# Access Compliance Report

## Public Rights-of-Way

### (Curb Ramps)

Intersection ID: 10025390	Main Street: E_9TH ST	Cross Street: N_MYERS_ST	Location: N
ADA ID: 9BC25296007E	Ramp Type: PerpDiag	Initial Pass/Fail: Fail	Overall Compliance: No
			Severity Score: 33.75

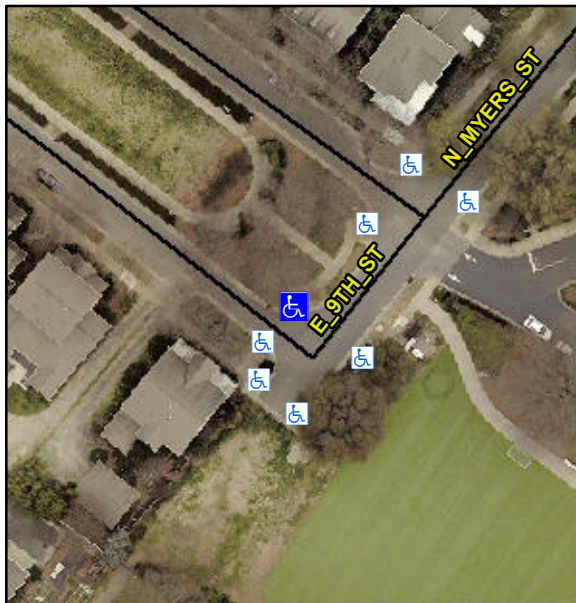
**Not Found, R304.5.1, R304.5.3**

Compliance	Description	Data	Compliance	Description	Data
N/A	Ramp Length (in)	72.0	Yes	Ramp Slope (%)	6.9
No	Ramp Width (in)	38.0	No	Ramp XSlope (%)	7.6
N/A	Flare Type LT	N/A	N/A	Flare Type RT	N/A
N/A	Flare Slope LT (%)	N/A	N/A	Flare Slope RT (%)	N/A
N/A	Flare Traversable LT?	N/A	N/A	Flare Traversable RT?	N/A
N/A	Landing Length (in)	N/A	N/A	DWS Provided?	N/A
N/A	Landing Width (in)	N/A	N/A	DWS Contrast?	N/A
N/A	Landing Slope (%)	N/A	N/A	DWS Length (in)	N/A
N/A	Landing X Slope (%)	N/A	N/A	DWS Full Width?	N/A
N/A	Landing Curb? (Y/N)	N/A	N/A	DWS Offset (in)	N/A
N/A	Shared Landing?	N/A			
N/A	Gutter Ponding?	N/A	N/A	Gutter Slope (%)	N/A
N/A	Gutter Lip Ht (in)	N/A	N/A	Gutter X Slope (%)	N/A
N/A	Painted X Walk1?	No	N/A	Painted X Walk2?	No
	X Walk 1 Direction	To SW		X Walk 2 Direction	To SE
N/A	X Walk 1 Width (in)	N/A	N/A	X Walk 2 Width (in)	N/A
	X Walk 1 Slope (%)	5.0		X Walk 2 Slope (%)	0.7
	X Walk 1 X Slope (%)	1.0		X Walk 2 X Slope (%)	4.0

**Remove & Replace Curb Ramp With Two New Directional Ramps or Equivalent.**
